INDESIT company

Model type:
AVL85SEU

Commercial code:
F029891

Fig. n10402231

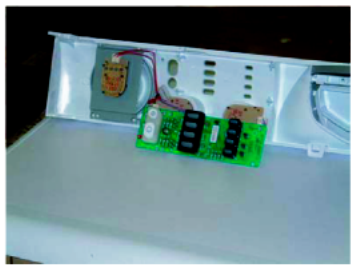
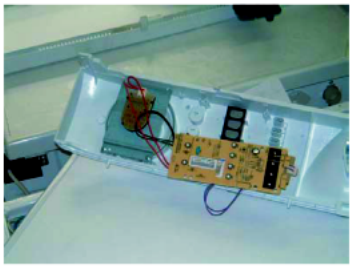
n1040331: Ariston LED restyling

From serial no. 40429.0001, models AVL, AVXL, AVSL, AML have been equipped with a new panel with well holes for the ON/OFF and RESET buttons and flush plastic light diffusers in place of the projecting siliconed ones (see picture n10402231

Fig.02). These features determine whether an appliance is modified or premodification.
The modification has also involved the electronic card whose panel and display communication connectors are on the left and not at the back (see picture n10402232 Fig.2).

For both models
C00143338 - LED CARD EVOII AVL /BUILT-IN ARISTON
C00110115 - WHITE BUTTONS ON-OFF/RESET EVOII LED KIT
C00109854 - PANEL WIRING LBE EVOII
C00110055 - SILICONED BUTTONS AVL-AVSL
C00110059 - PANEL WIRING -DISPLAY 240000848B2.
C00111227 - WIRING MAIN - DISPLAY 24000084804B1 (POLARIZED).
The new parts are only interchangeable with the pre-modification ones if used altogether. They are not individually interchangeable.

Fig . 001

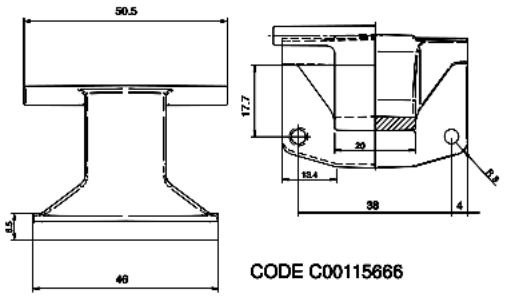
n1040349: Introduction of 150° Zamac hinge on Ariston 46 models.

From serial no. 50207.0001, all Ariston models produced in the Teverola factory (see table 001 attached) with industrial code (given on the rating plate) starting with 46, have been equipped with a Zamac hinge with 150° opening angle, code C00115666 (see Fig.001).
This modification has involved the introduction of the following items:

Code C00115670 - Complete door EVOII 150° white 27 with standard glass;
Code C00115674 - Complete door EVOII 150° white 27 with long glass;
Code C00115667 - EVOII body for 150° hinge white 27;

The premodified items are not interchangeable separately with the modified ones.

Fig . 001

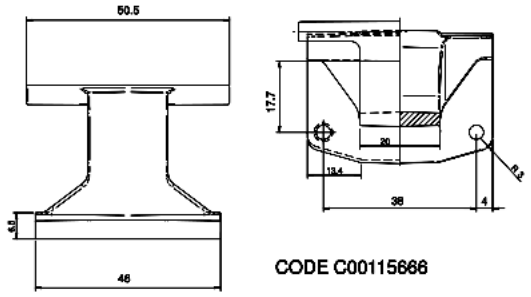
n1040353: Introduction of 150° Zamac hinge on Ariston models (Comunanza).

From serial no. 50207.0001, all Ariston models produced in the Comunanza factory (see table 001 attached) with industrial code (given on the rating plate) starting with 80, have been equipped with a Zamac hinge with 150° opening angle, code C00115666

(see Fig.001).
This modification has involved the introduction of the following items:

Code C00115670 - Complete door EVOII 150° white 27 with standard glass;
Code C00115674 - Complete door EVOII 150° white 27 with long glass;
Code C00115668 - Complete door EVOII 150° silver with standard glass;
Code C00115673 - Complete door EVOII 150° silver snella standard glass;
Code C00115662 - EVOII body for 150° hinge white 27
Code C00115663 - EVOII body for 150° hinge silver 27
Code C00115664 - Snella EVOII body for 150° hinge white 27
Code C00115665 - Snella EVOII body for 150° hinge silver

The premodified items are not interchangeable separately with the modified ones.
